Project	IEEE 802.21a < https://mentor.ieee.org/802.21 >
Title	A Summary of Raised Issues in the Current Existing Options
DCN	21-09-00xx-00-0Sec
Date Submitted	May 11, 2010
Source(s)	Lily Chen (NIST)
Re:	Discuss at IEEE 802.21 session #37, May 10-13, 2010
Abstract	This document summarizes the raised issues in the current options for work item 1 and work item 2.
Purpose	To initial discussions on these issues at meeting #37.
Notice	This document has been prepared to assist the IEEE 802.21 Working Group. It is offered as a basis for discussion and is not binding on the contributing individual(s) or organization(s). The material in this document is subject to change in form and content after further study. The contributor(s) reserve(s) the right to add, amend or withdraw material contained herein.
Release	The contributor grants a free, irrevocable license to the IEEE to incorporate material contained in this contribution, and any modifications thereof, in the creation of an IEEE Standards publication; to copyright in the IEEE's name any IEEE Standards publication even though it may include portions of this contribution; and at the IEEE's sole discretion to permit others to reproduce in

Figure 1. EAP over MIH for proactive authentication – Work Item 1.

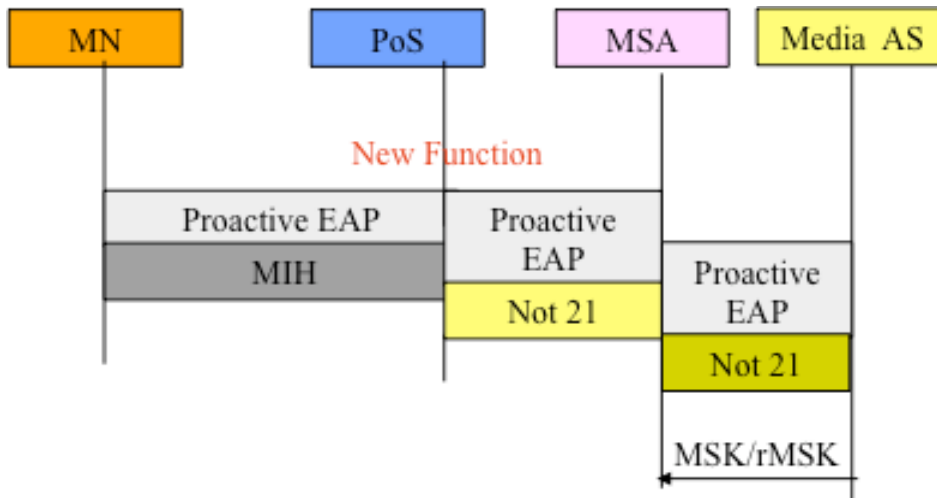
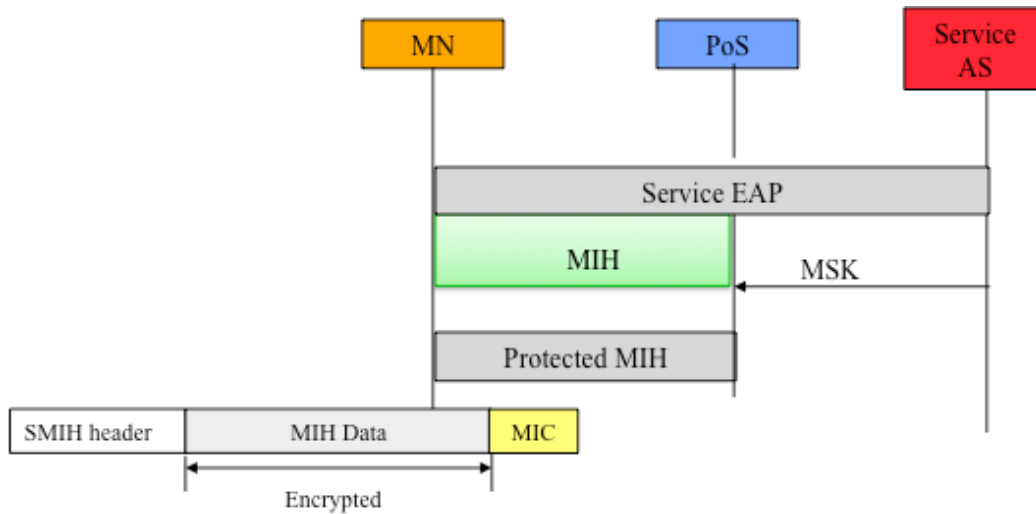
The issue is how PoS can distinguish the two situations:

1. As an authentication message routing device (do not process, only encapsulate and decapsulate);
2. As an authenticator (process or pass using AAA).

1. Can we add different flags in MIH message for proactive media authentication and for service authentication?
